STAFF REPORT
Docket No. SP-53-23
Summary No. 26302
Site Plan Review
Home 2 Suites Hotel

Construction of a new, 5 story, 106 room hotel and parking lot

Site Plan & Variance Request

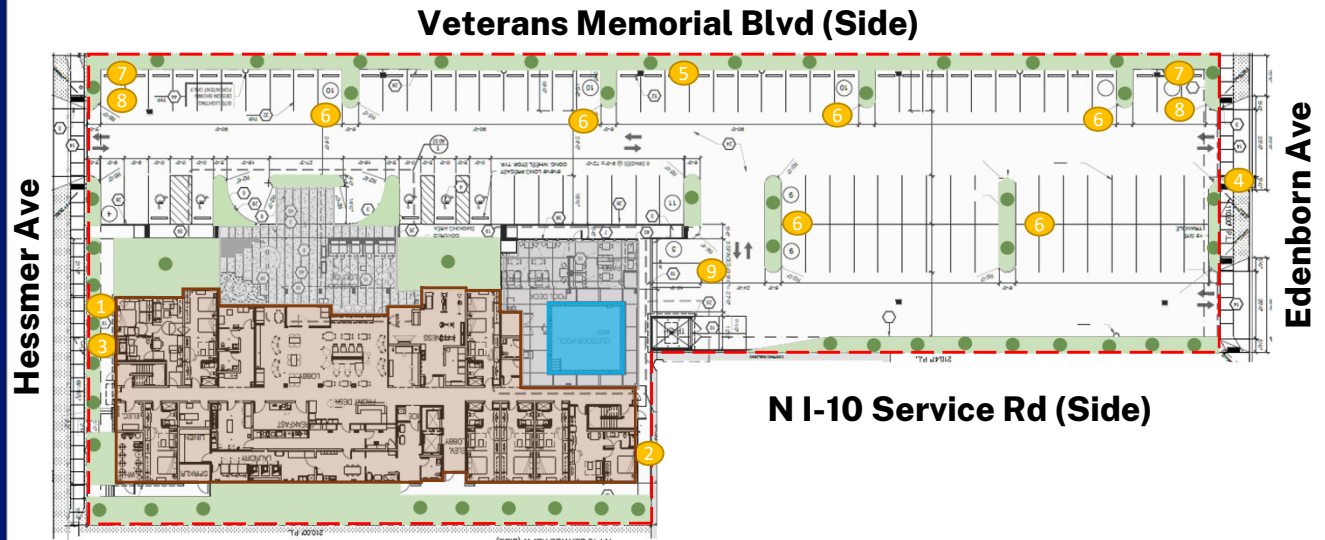
5. The applicant has requested variances to the following regulations:
 - a. Per section 40-424 (1) a., the area regulations of the BC-2 Business Core district require a 20 ft. front yard, and through lots shall provide said front yard on both frontages. The proposal includes a 10 ft. front yard on the Hessmer Ave side; a variance for 10 ft. is required.

- b. Per section 40-424 (1) b., the area regulations of the BC-2 Business Core district requires 10 ft. side yards. The proposal includes a 5 ft. side yard

along the south east corner of the hotel and, as such, a variance for 5 ft. is required.

- c. Per section 33-6.25.5 (b), streetscape landscaping areas equal in width to the underlying zoning district's front yard requirement are required along each right-of-way. 20 ft. of streetscape landscaping is required along both the Hessmer Ave and the Edenborn Ave right of ways. Between 4 ft. and 10 ft. of landscaping is provided on the Hessmer Ave side and, as such a variance for 16 ft. is required. On the Edenborn side, only 2.5 ft. of landscaping is provided and, as such, a variance for 17.5 ft. is required.

- d. Per section 33-6.25.5 (d) (1) b., parking lot perimeters where vehicular use areas on different development sites abut, a minimum 5 ft. continuous buffer with 1 class A tree per every 35 linear feet, or portion thereof, plus a living fence, grass, or other groundcover, shall be provided between the abutting vehicular use areas. A 5 ft. buffer with 13 trees is required on the Veterans Memorial Blvd side. The proposed buffer is 4.5 ft. wide and contains 11 trees, thus, a variance for 0.5 ft. of width and 2 trees is required.

- e. Per section 33-6.25.5 (d) (2) c., parking lot interior islands must be provided every 10 contiguous parking spaces, endcaps must be provided at the end of each row of parking spaces, each island or endcap shall be minimum of 5 ft. in width, each island or endcap shall contain 1 class A tree, and said trees require 100 sq. ft. of planting area per section 33-6.25.6 (a) (6). The parking lot interior islands are 75 sq. ft.; a variance for 25 sq. ft. is required. The provided endcaps are 4.5 ft. wide and 90 sq. ft.; variances for 0.5 ft. of width and 10 sq. ft. of area are required. The proposal does not include an endcap on the row of parking spaces abutting the dumpster enclosure; a variance for a missing endcap is required.

- f. Per section 33-6.25.5 (d) (3), for development sites with more than 40 required trees no single species shall comprise more than 20% of the total number of trees required. 27% of the provided trees are Eagleston Hollis and 24% are Nuttall Oaks. A variance to the species diversity regulation is required.

The proposal does not comply with the CPZ requirements to the maximum extent possible. There are no space limitations and no existing structures. The site is large enough to meet all BC-2 hotel regulations. The front yard, side yard, and streetscape landscaping requirements can be met by

relocating the proposed building or reducing the size of the proposed building. The BC-2 district permits exceptions to the maximum height allowed by right of 65 ft. per section 40-423 (b). The building height could be increased, the building footprint reduced, and there would be no reduction in the number of hotel rooms. The landscape buffer on the Veterans Memorial Blvd side of the property may be widened, and the proper number of trees may be provided. The undersized landscape islands and endcaps may be enlarged to meet the requirement. The missing landscape endcap may be added to the parking row near the dumpster enclosure. The species diversity requirement may be met by reducing the number of Eagleston Hollies and Nuttall Oaks and providing an additional tree species.

The proposed hotel is too close to both a front and side lot line, and thus it is encroaching on required open space near an adjacent property and right of way. There is missing landscaping along the streetscapes, within the parking lot, and along the Veterans Memorial Blvd side of the lot. Per section 33-6.25.1 (b), one of the purposes of the landscaping requirements is to reduce the negative environmental effects of development while enhancing and protecting property values and public and private investments. Additionally, the species diversity requirement is in place to prevent disease and pest problems that may devastate a particular species of tree. The diversity requirement helps protect the Parish's tree canopy by avoiding monocultures that can be wiped out by a single disease or pest. The request includes a number of landscape variances that are easily resolvable. The granting of these variances would be in conflict with the stated purpose of the landscape regulations, impinge on adjacent properties, and be detrimental to the Parish's tree canopy.

Elevations

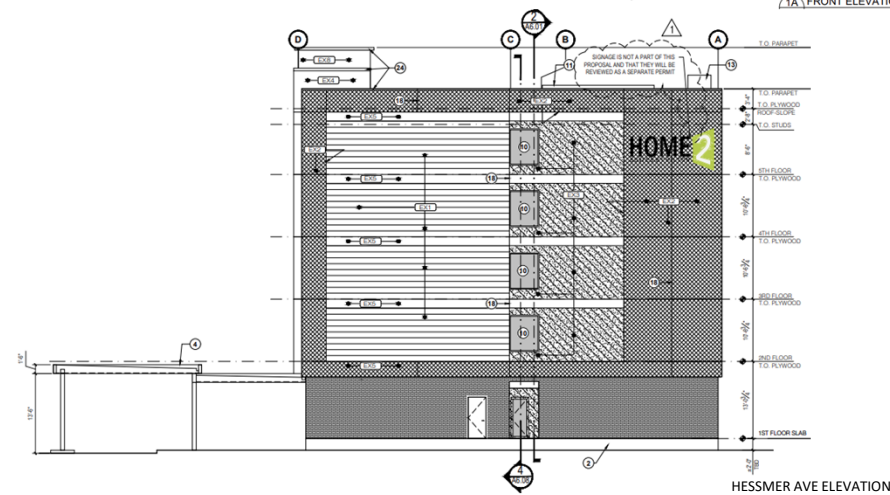
Height of 59.25 ft.
(elevator shaft extends higher)
